# Manhattan Community Board 4

## NYS Liquor License/DOT Dining Out Stipulations Application

## COMMUNITY BOARD RECOMMENDATION FORM

**Business Name:** BOCCA DI BACCO

## SECTION 1: Site Plan

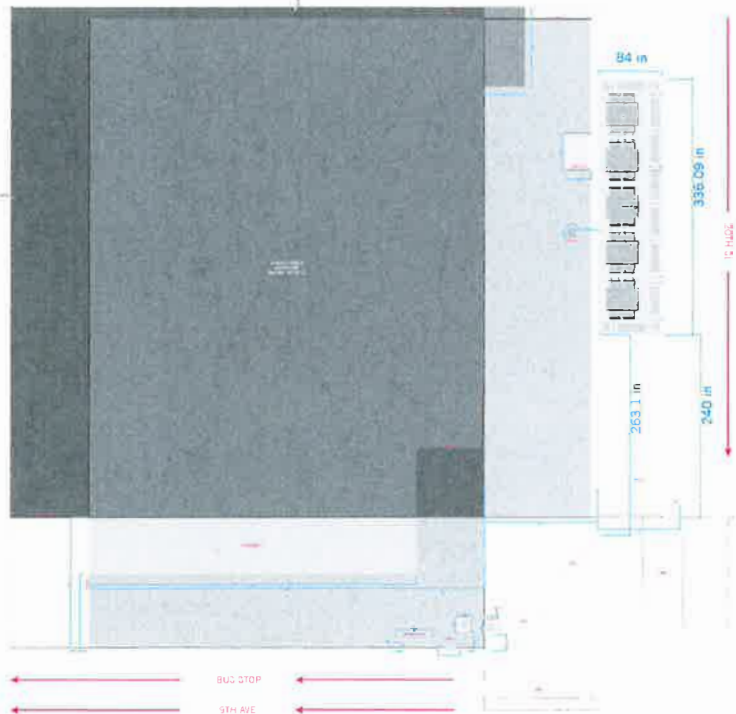
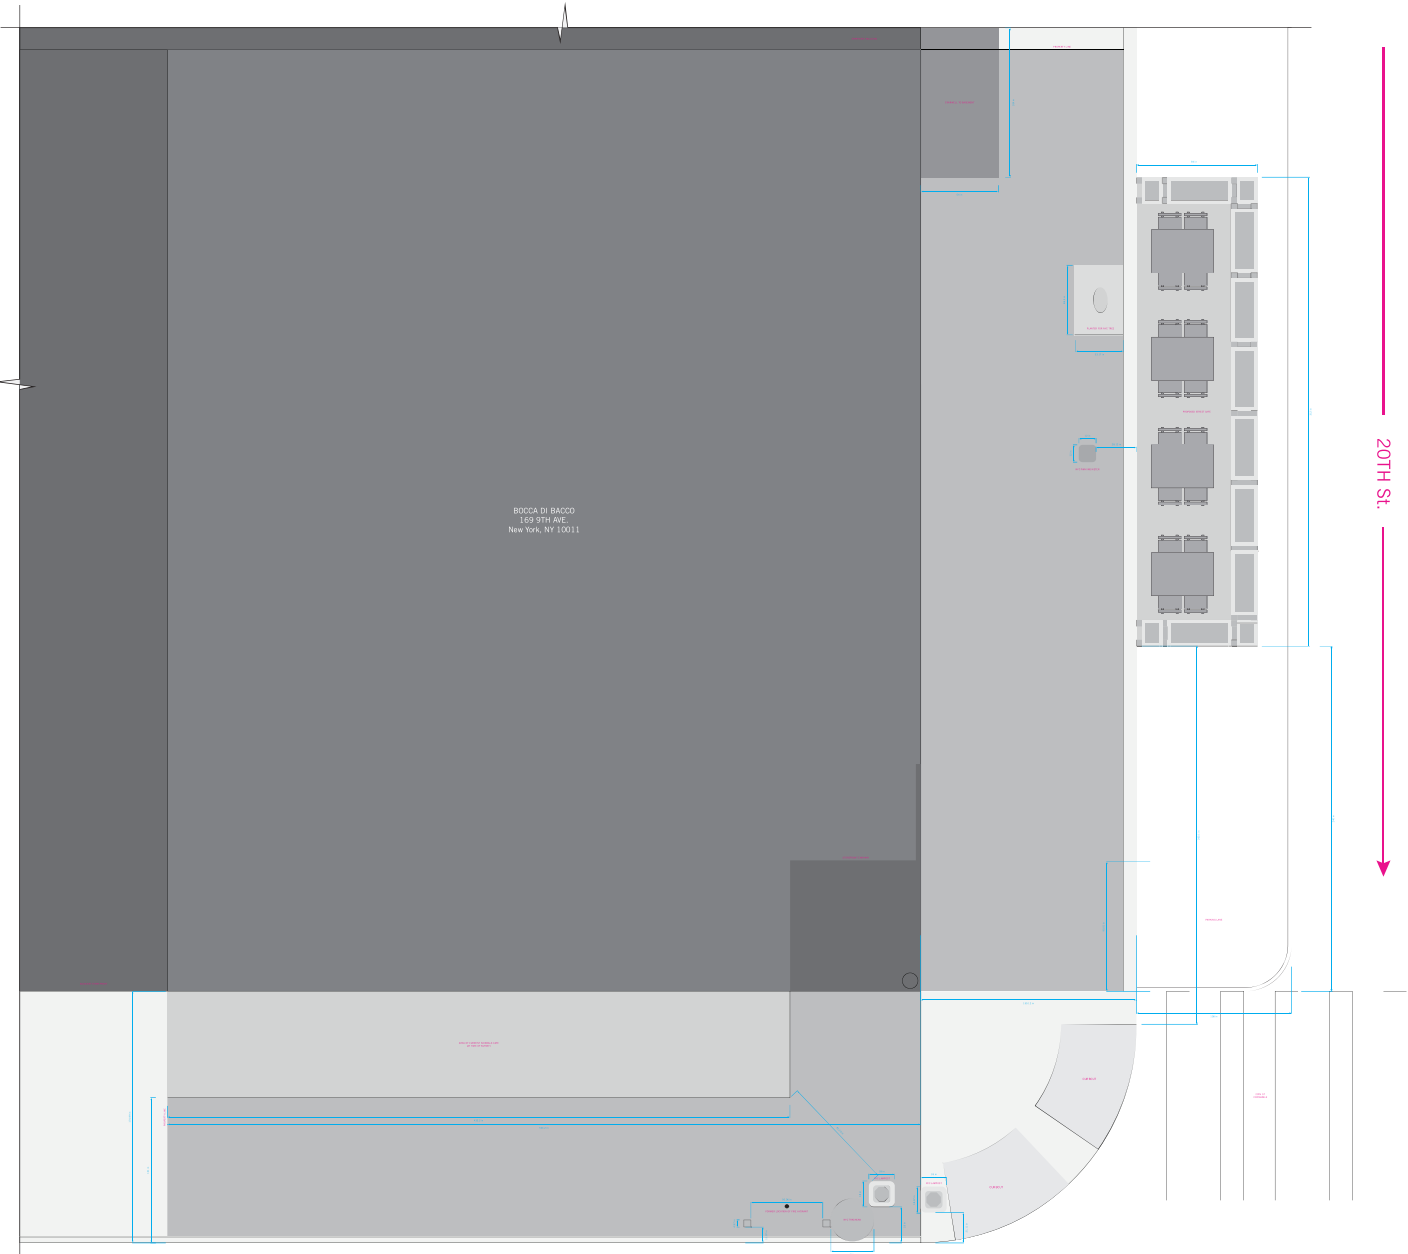
**Inaccurate Measurements:** The drawing properly represents that that cafe starts after the 20ft distance from the crosswalk and ends parallel to the basement entrance to the adjacent building. However the measurements are inaccurate: the length of the cafe is 26ft - not 28ft as indicated.

- 1. Reduce the length of the roadway cafe to 26 ft.**
- 2. Add serving aisles within the cafe**
- 3. Change to 4 tables and 16 chairs**
- 4. Remove the illegal sidewalk cafe on 9th Avenue**

\*REVISED  
SITE PLAN

Length of roadway cafe: 26 feet      Width of roadway cafe: 7 feet
